YEAR 4 of 5 Monitoring Report
Tributaries of Wicker Branch Stream Restoration
Union County, North Carolina
DMS Project Number: 95022
Contract No: 003982
USACE Action Id No: SAW 2013-01680

RE: Year 4 (2018) Monitoring Report the Tributaries of Wicker Branch Project (DMS Project # 95022)

To	Harry Tsomides, DMS Project Manager	Page	1
CC			
Subject	Tributaries of Wickers Branch – 10/16/2018 Site Visit Comments		
From	Ron Johnson		
Date	January 23, 2019

2. Stream Assets Map
 Tributaries of Wicker Branch
 Stream Restoration Site (DMS No. 95022)
 Union County, NC

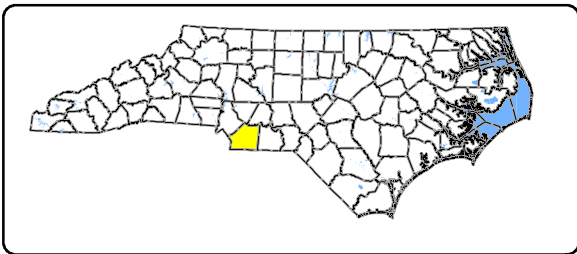
Stream mapping – It appears trib 4 may be migrating out of the easement before reentering it; this will need to be analyzed and rectified if necessary since any streams outside the easement will not yield assets.

This should not be an issue with asset generation. The very upper portion of Tributary 4 (shown in black) is not included in the asset calculations. As shown on the figure to the left only the lower 631 feet of Tributary 4 is generating credits (highlighted in green).

The Asset map submitted with the MY4 report was updated to more accurately reflect which portions of Tributaries 3 and 4 are generating assets.

FIGURE 3

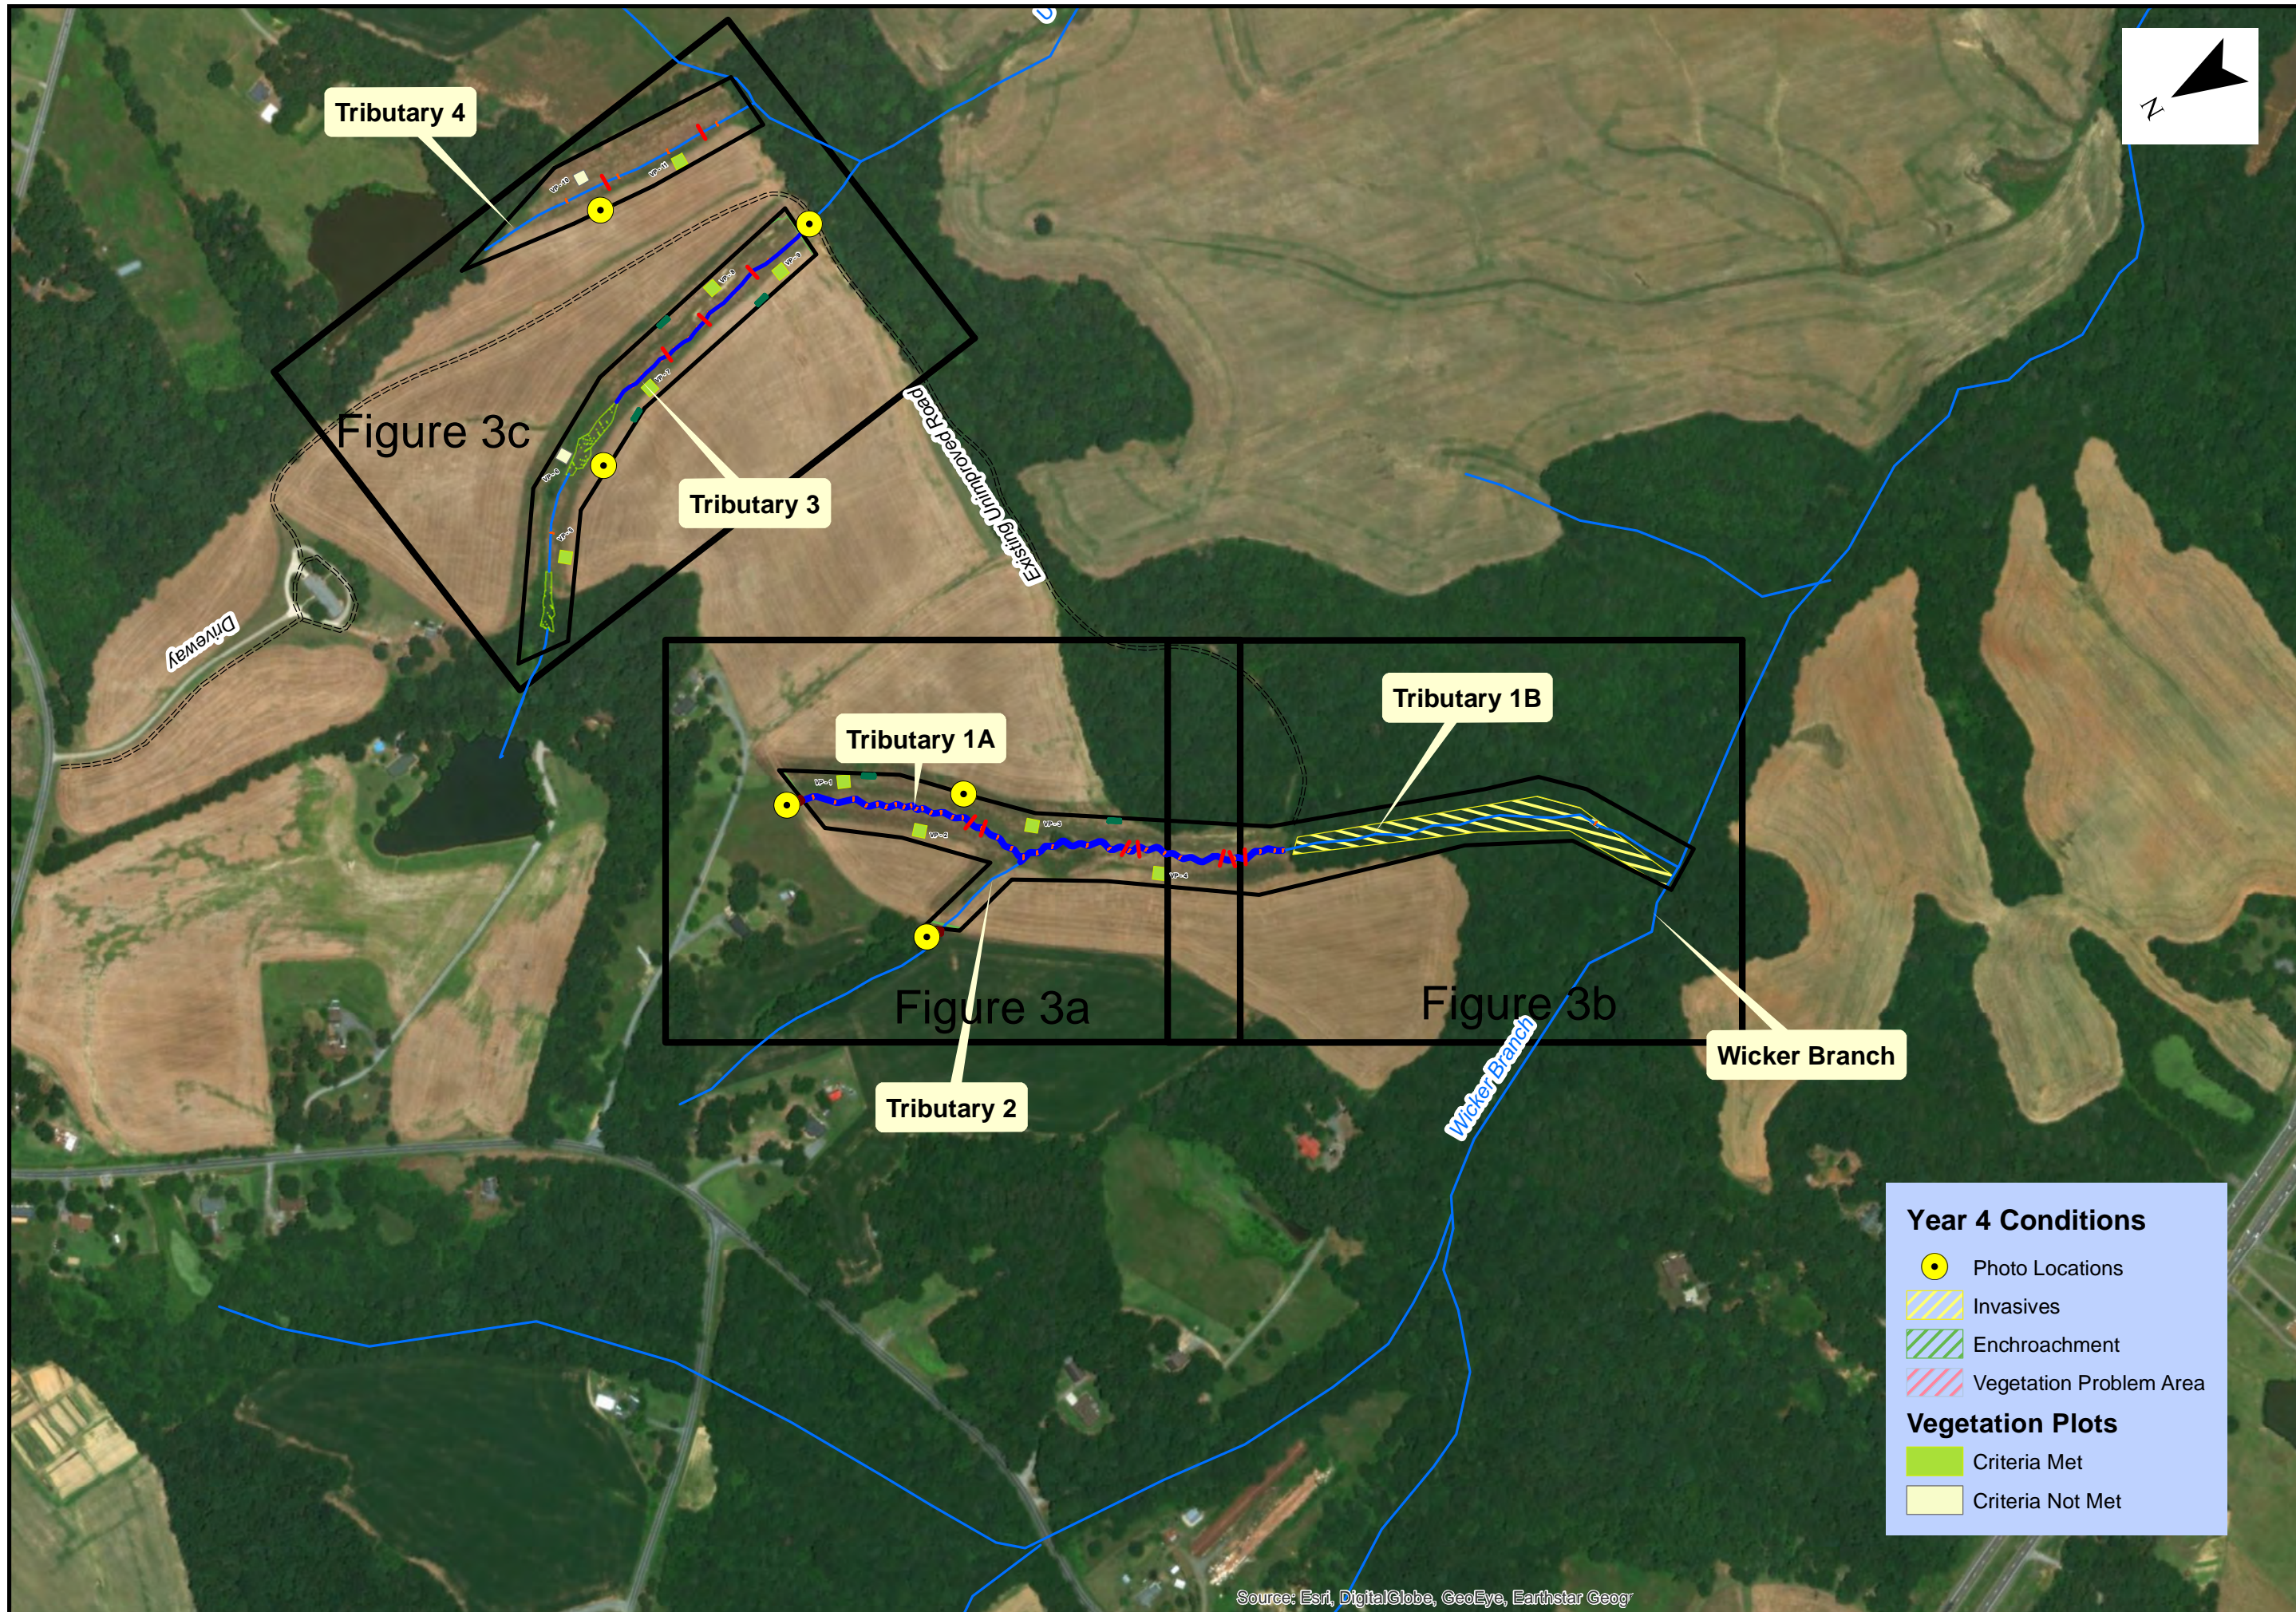
Please confirm transducer locations are accurately mapped on the CCPV.

Transducer locations have been confirmed and updated locations are shown on the CCPV that was submitted with the MY 4 report.
